Change of External Appearance of the MELSEC iQ-R Series Base Units

FA-A-0374-A

Extension connector cover and rating plate

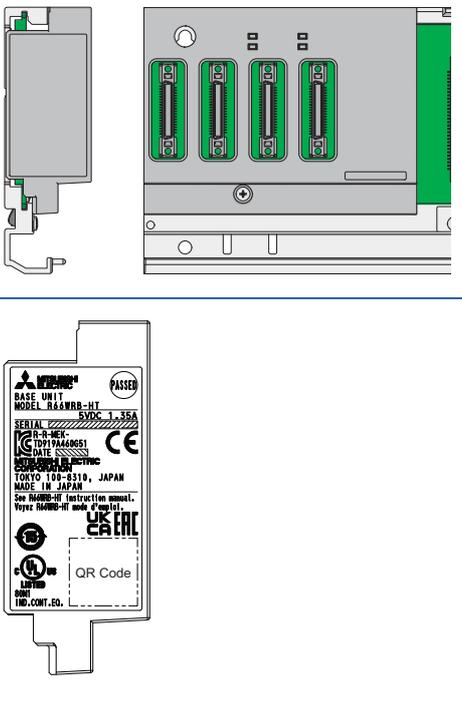
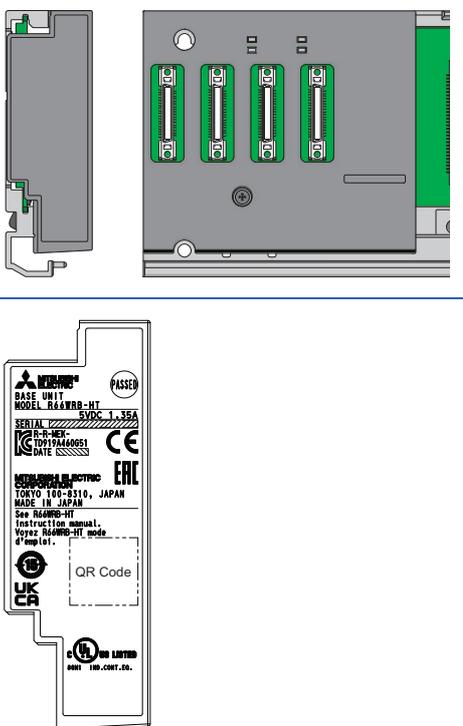
For the MELSEC iQ-R series base units, the shape of extension connector cover and the information layout of the rating plate will be changed.

Model	Before change	After change
R33B, R35B, R38B, R312B, R310RB, R310B-HT, R38RB-HT	 <p>A sticker is on the top.</p> <p>(The R33B has no sticker.)</p>	
		 <p>(For the R33B, the indication required by the standard of ANSI/ISA-12.12.01 will be added to the rating plate of the products manufactured on and after June 2022.)</p>
